Four Brothers Fashion (Extension)

22 April 2024

2. Observations:

5 CONCLUSION

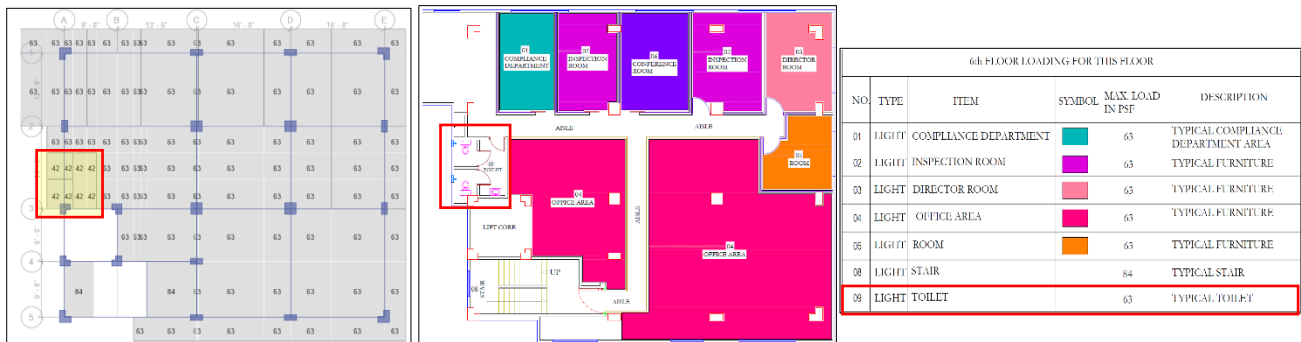
The factory has performed a Detailed Engineering Assessment (DEA) for the building. The structure has been considered as an Intermediate Moment Resisting Frame (IMRF) system ($R=S$). However, in the report, adequate information and calculations have not been provided to support the framing system as IMRF.

A building engineer is required to revise the DEA documents based on the above observations and submit to RSC for further review.

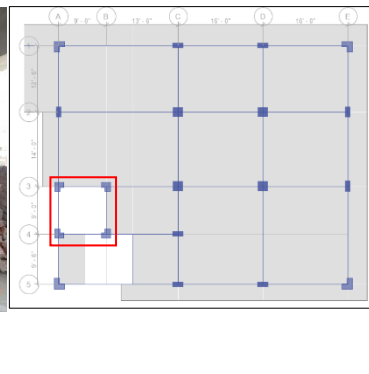
The assignment of the floor loading do not match between FEA model and load plan. Floor live load has been considered 3kPa for the toilet zone but in FEA model 2kPa has been assigned.

2.3 MATERIAL PROPERTY

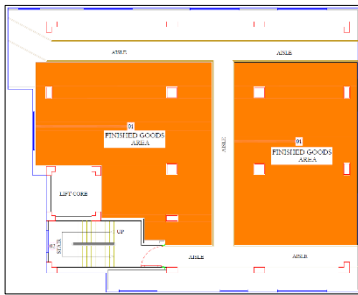
In the DEA, the tensile strength of the re-bar has been considered 500MPa but no test report is available. During the inspection, the floor layout plan was found mismatch with the provided as-built architectural drawing. Newly brick wall have been constructed on floors that are not shown in the drawing. The opening of the lift core has been shown in the floor layout and assigned in the FEA model, but at the site lift core opening was not found. A Cantilever slab was found which has not been shown in the architectural drawing.
